## Technical Memorandum #2

**RE:** Response to Review Comments for Highway 286/Dave Ward Dr. Roundabout Review

**DT:** March 24, 2015

**6.7.1 – Fastest Path Checks**

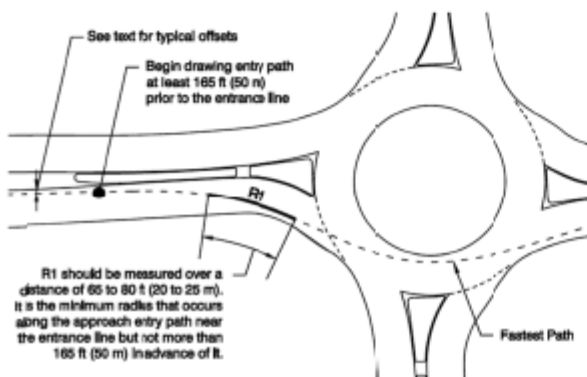
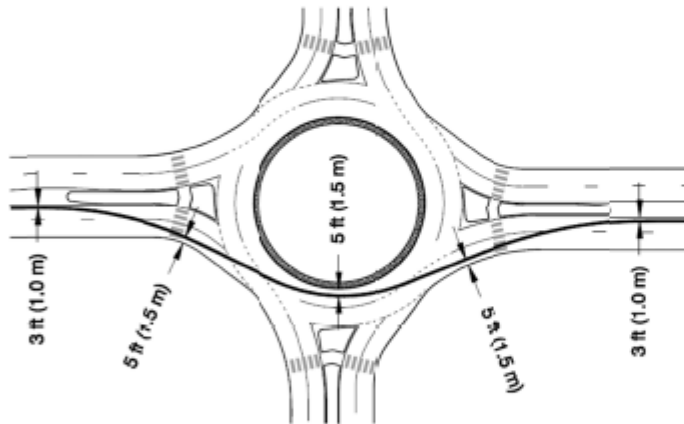
There are several noticeably incorrect fastest paths shown in the diagram provided by MTJ. The entry from the southern approach of roundabout 1 (ramp 3) crosses over an island, and the western approach into roundabout 1 does not

adhere to the correct offset to the entry island. The proposed entry speeds listed on the southern approach of roundabout 2 (South Amity Road) are also substantially off since they are all controlled by the 25mph curve entering the roundabout (within the 165' zone). It would be impossible for a vehicle to instantaneously reach 57mph coming through a 25mph curve. All of the fastest path checks created by Garver were created based on the recommended path criteria shown in Section 6.7.1.1. As noted in that section, the vehicle paths should be drawn 5' from a concrete curb, 5' from a roadway centerline, and 3' from a painted edge line (diagram below). As also mentioned in the guidelines, a tangent section should be included between the curves to account for the time it takes for a driver to turn the steering wheel. Several of the paths shown by MTJ do not appear to adhere to these criteria. Most of the paths shown lack a tangent section between the curves, and several of the offsets do not match the recommended offsets. The path alignments developed by Garver utilize the criteria presented in the NCHRP report and were developed utilizing the recommended "B-spline" curve method presented in the Wisconsin Guidelines. The roundabout entry widths were developed to accommodate WB-67 vehicles in all approach lanes without creating over-tracking issues into adjacent lanes. Utilizing smaller radii or smaller lane widths will result inadequate space for WB-67 vehicles. As noted in Section 6.7.1.4, for multilane roundabouts, it is difficult to produce a balanced design to meet all of the criteria. **If the goal is to further reduce entry speeds, an easy modification of the existing design would be to simply add the low profile lane separation (vain islands) to the inside lanes (just like the outside lanes) to cut off any possible fast path movements.**

I agree with above explanation and recommendation to provide raised vain islands. Also, I recommend

locating stagger of yield Lines to provide the most appropriate viewing angle for approaching traffic.

The numeric values shown in our graphic representation of the fast paths were based upon actual fast path constructs from our CAD-level fast path checks (attached).

The graphical representation we provided was intended to visually represent the issue, and to show in relative terms how out of specifications the original fast path constructs were developed. These graphically produced fast path constructs were not intended to reflect the actual fast path construction. Therefore, any reference to them being out of compliance is not applicable. Please see attached actual CAD fast path constructs.

MTJ REVIEW - GEOMETRIC FAST PATHS REVIEW  
 3.24.2015

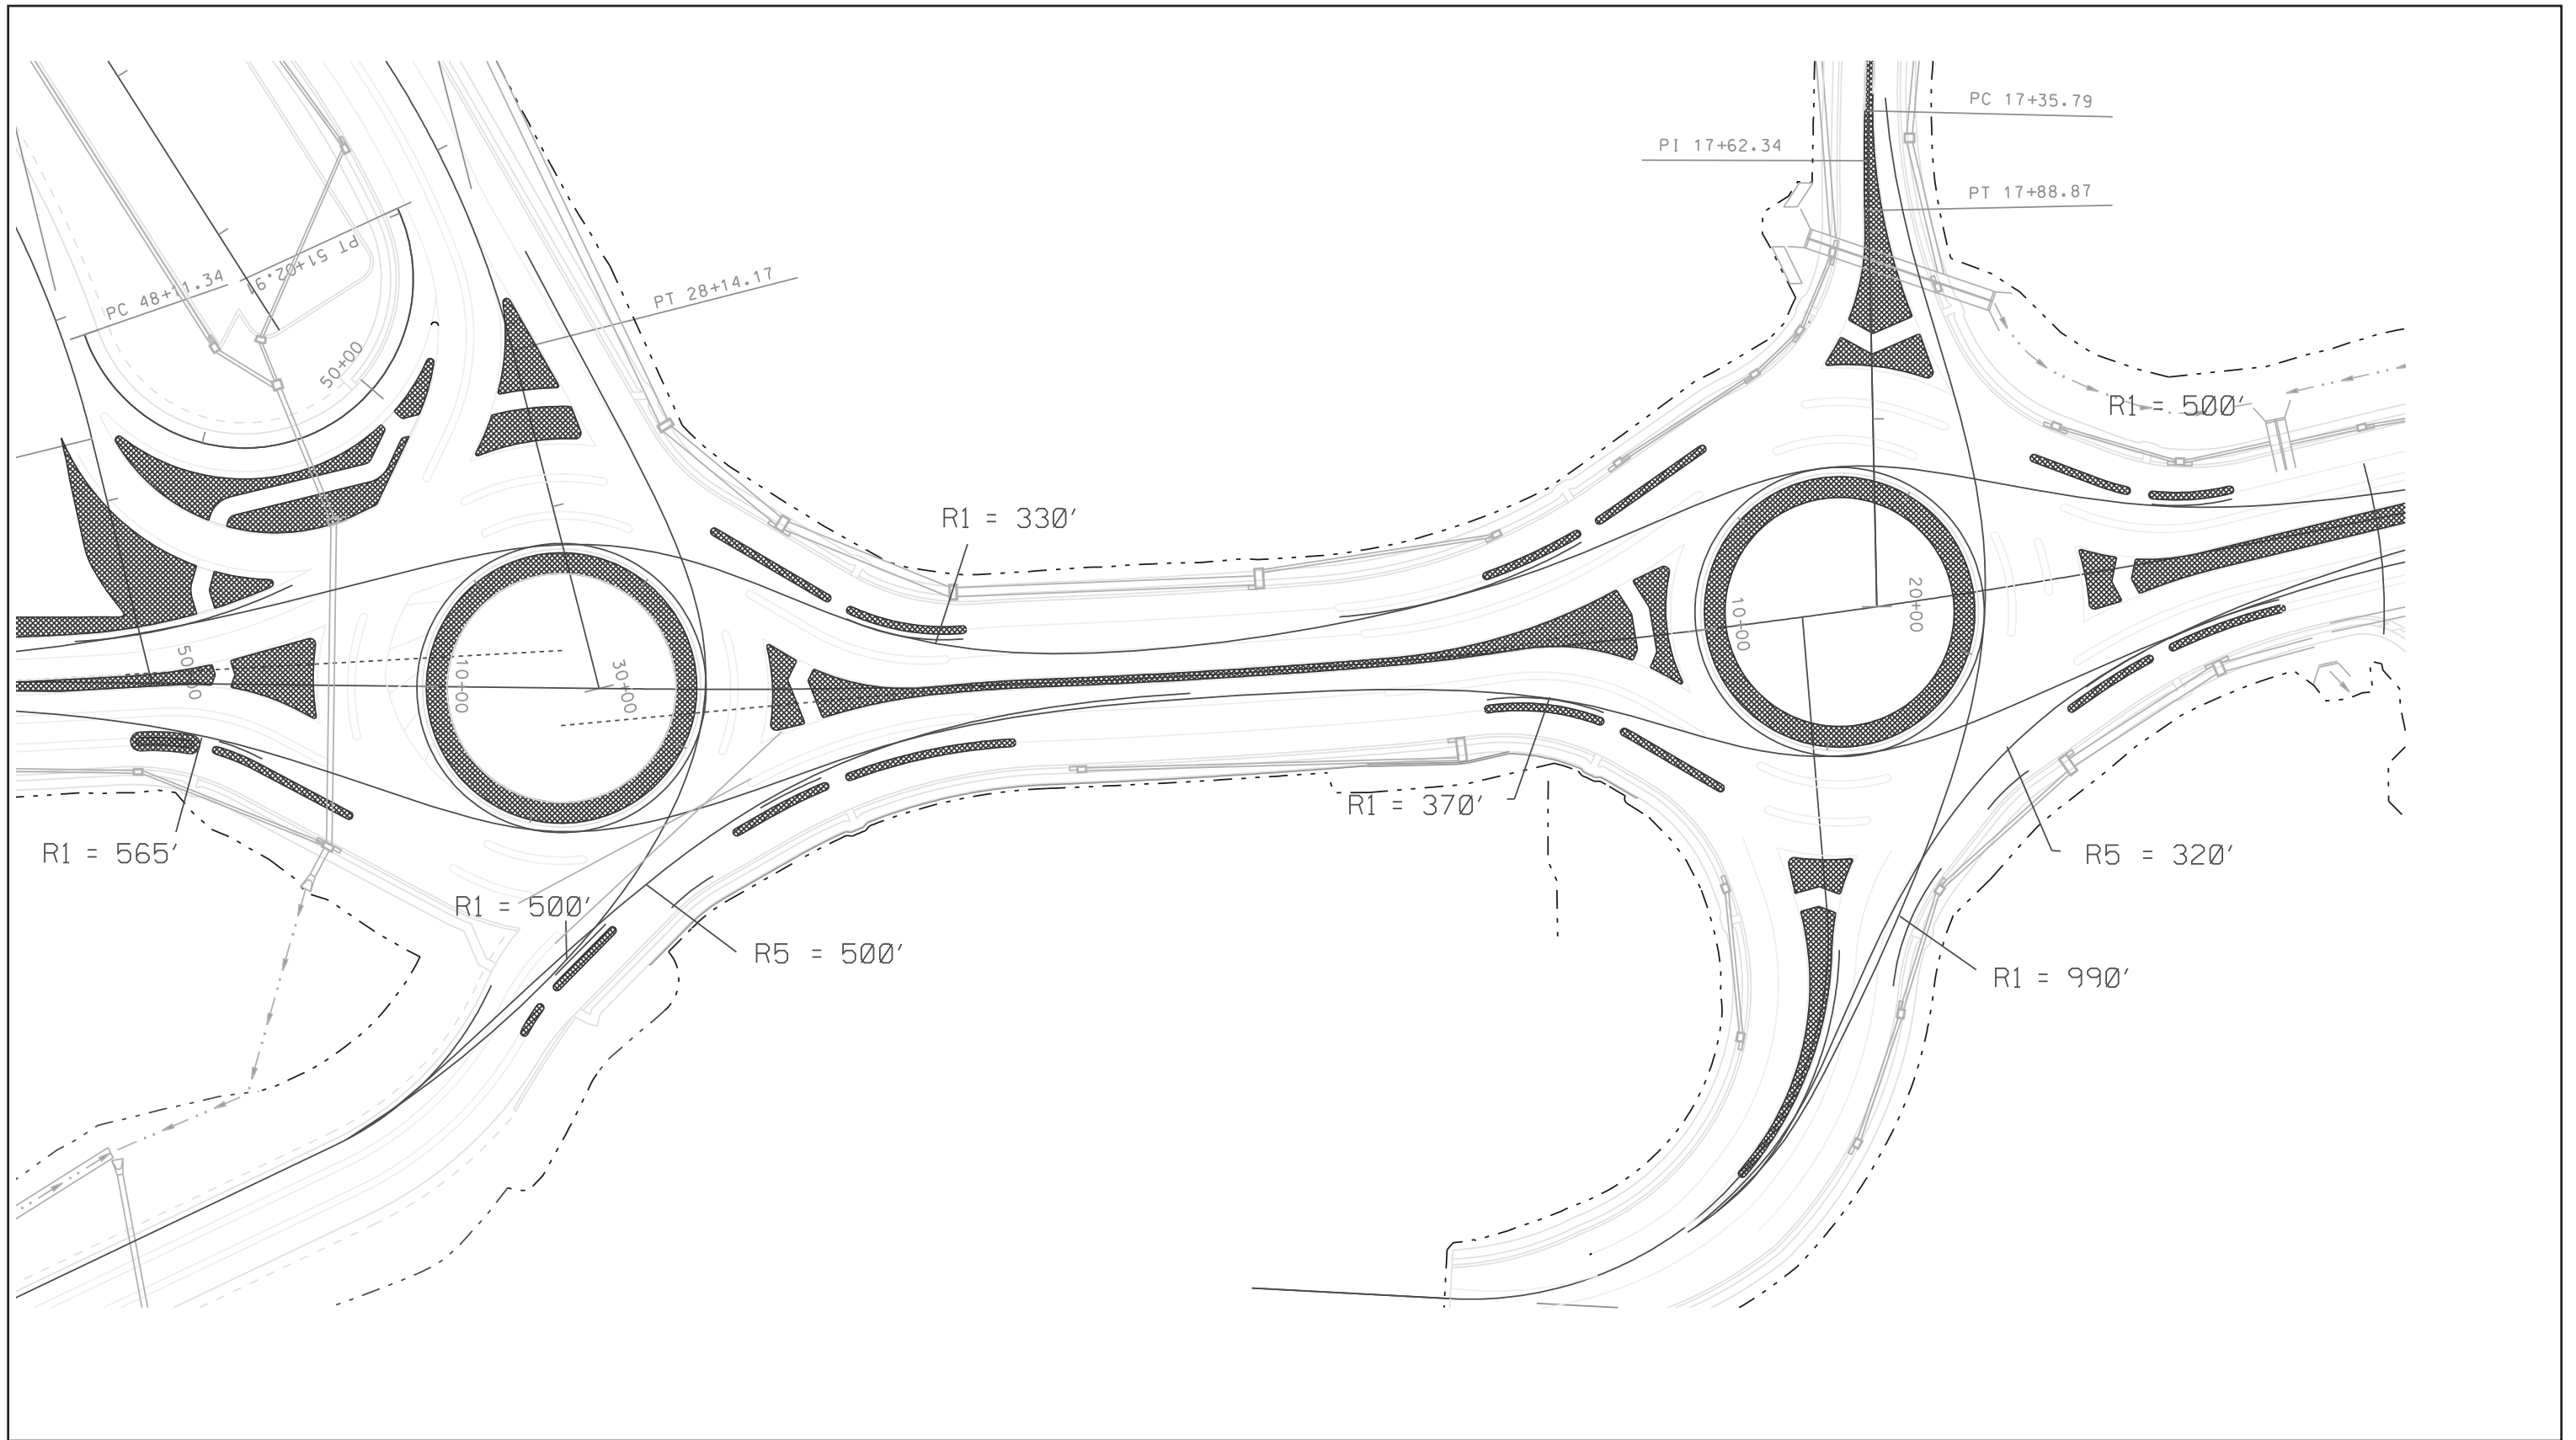
Phi = 15 degrees ÷ 2 = 7.5 degrees

**RECOMMENDATION**  
**Entry (Phi) Angle**  
 Preferred minimum  
 $40^\circ \div 2 = 20^\circ$   
 Phi = measured entry angle ÷ 2

ROUNDABOUTS 1 AND 2  
 CRITICAL DESIGN PARAMETERS

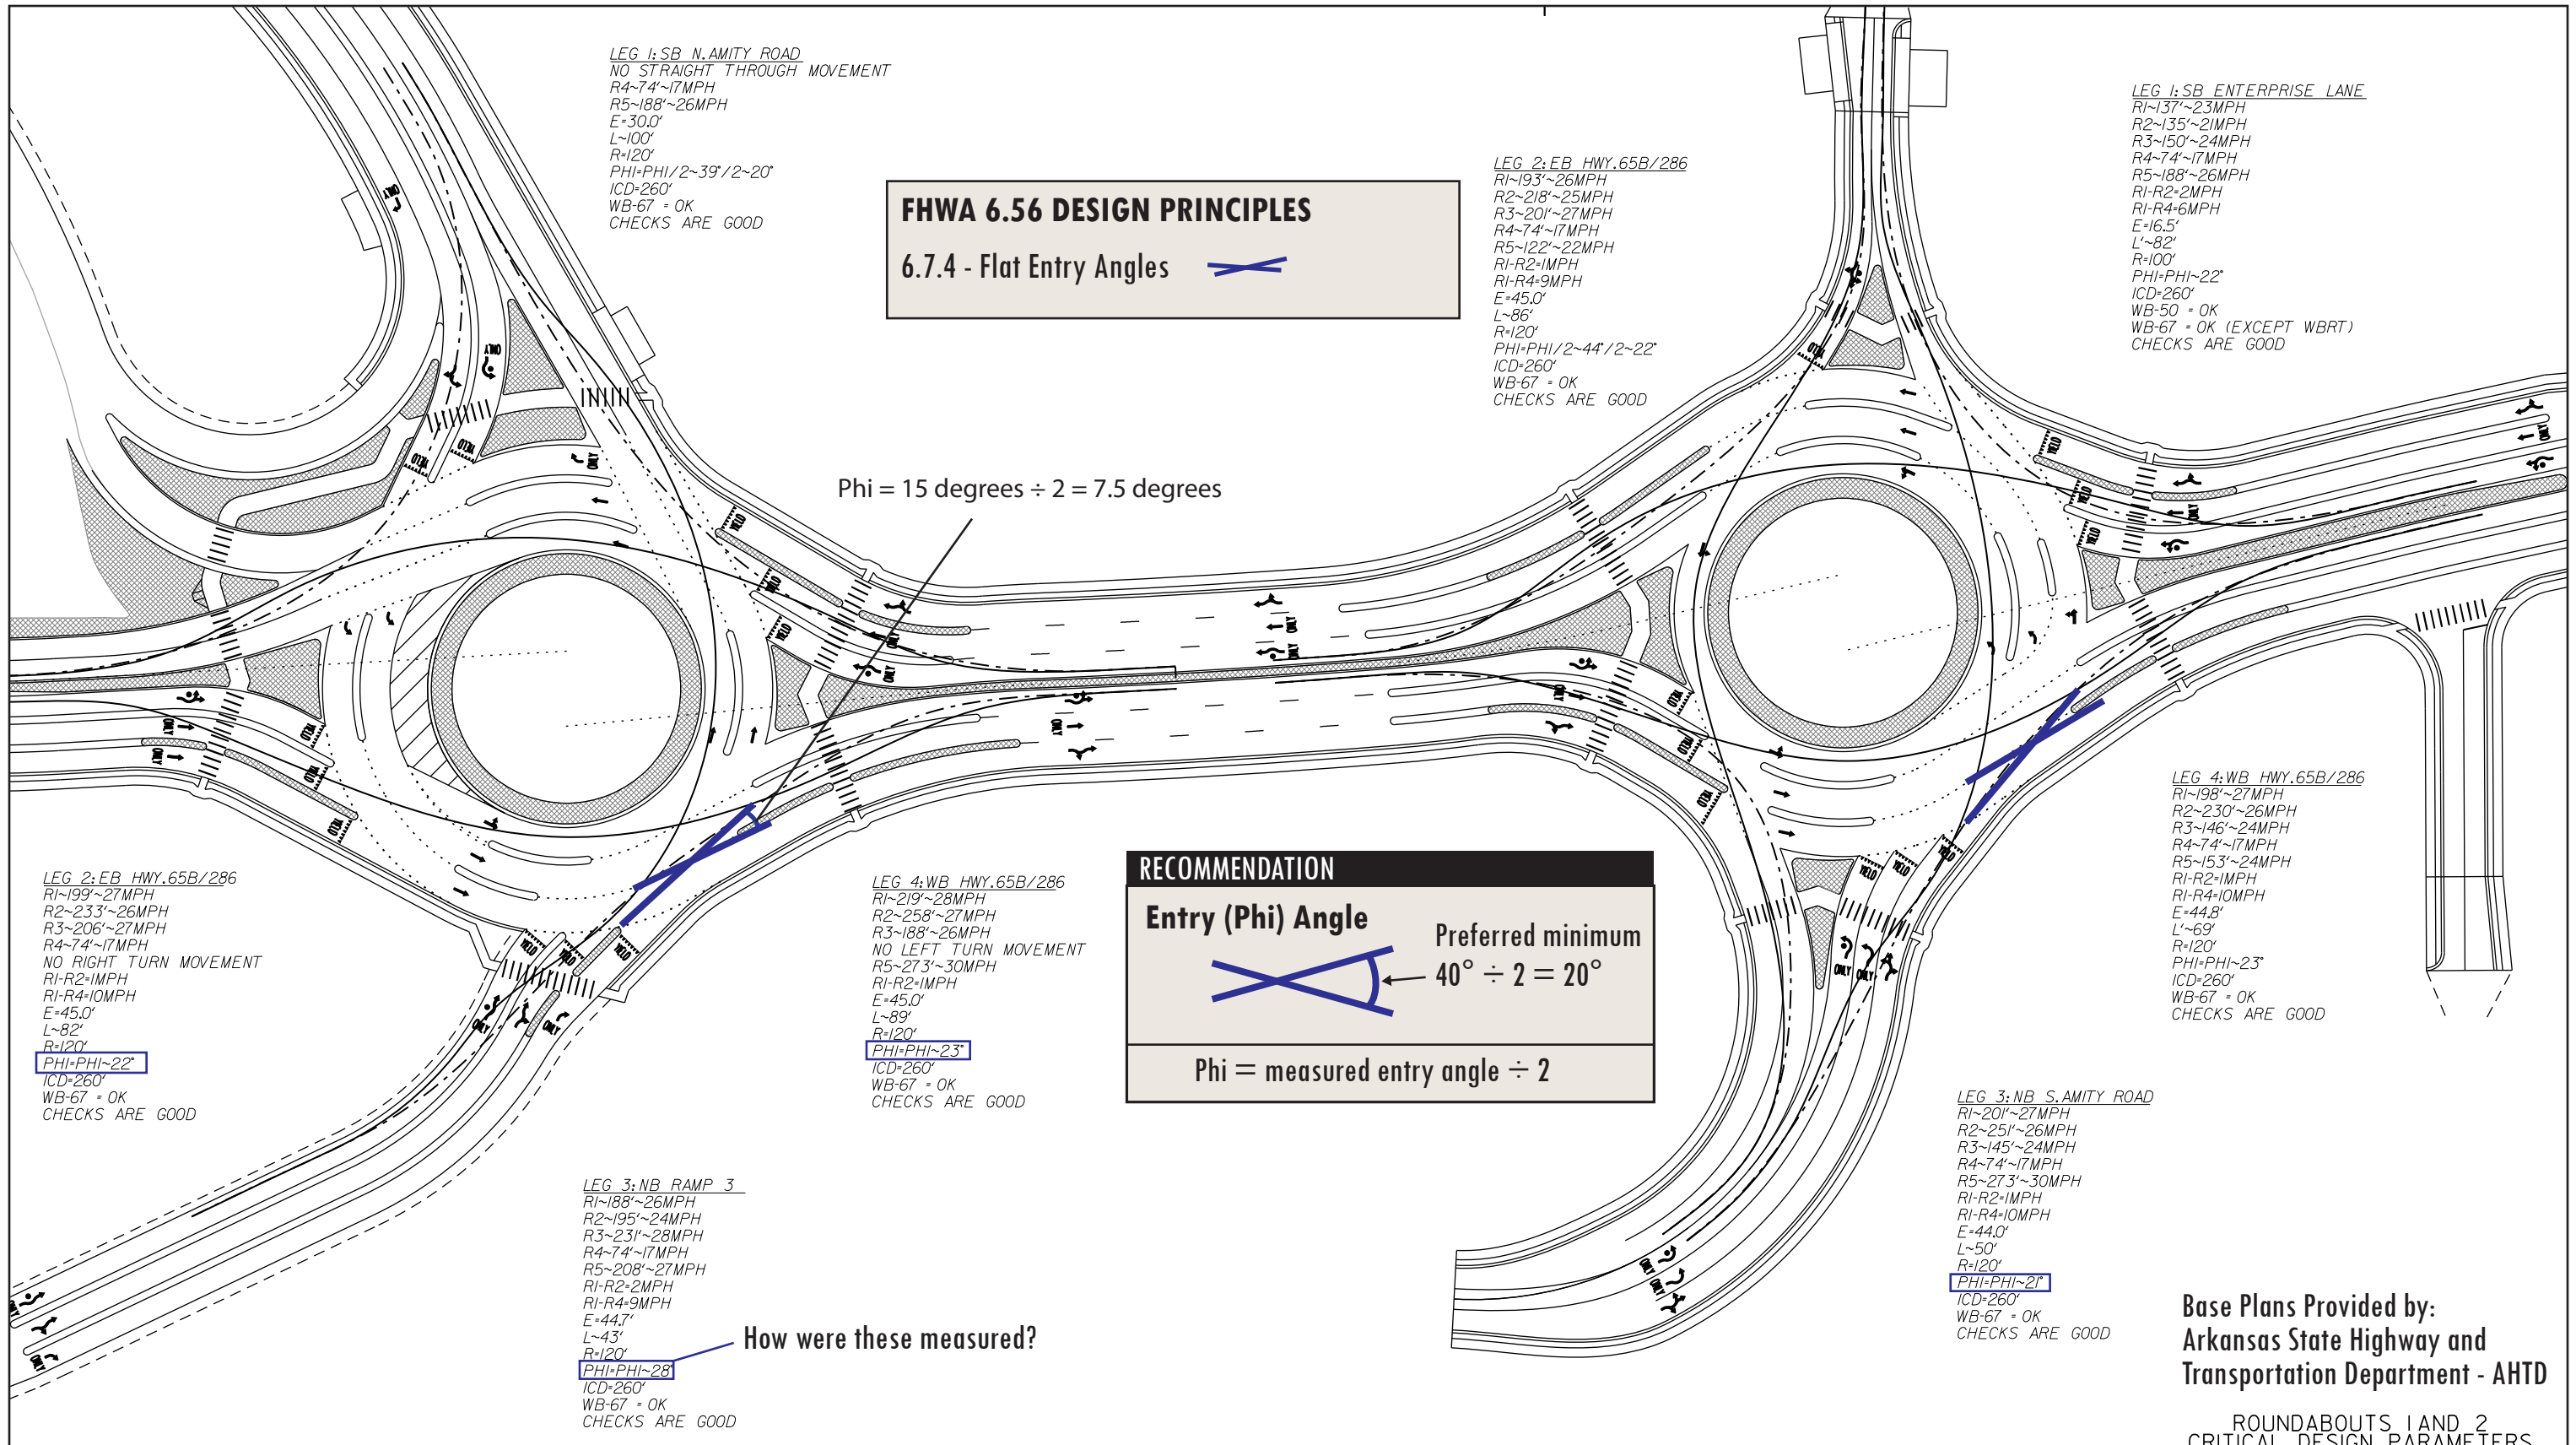
How were these measured?
